Forgetting About the Sun:

two different issues that arise for API000 Rev 19
Calculations

S G Sterrett, Carnegie-Mellon University
ACRS Meeting August 16th, 2011
Rockville, MD

Figure 6-6: Large Scale Test Facility

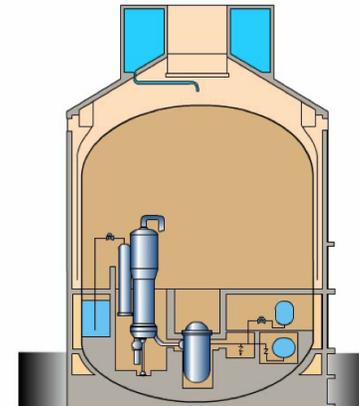
The test setup used to validate WGOTHIC code (methodology of calculation of peak containment pressure) is pictured on the left; the situation to which WGOTHIC was applied is on the right.

One is in the sun; the other is not.

How was the difference accounted for in interpreting test results to validate calc methodology in WGOTHIC computer code?
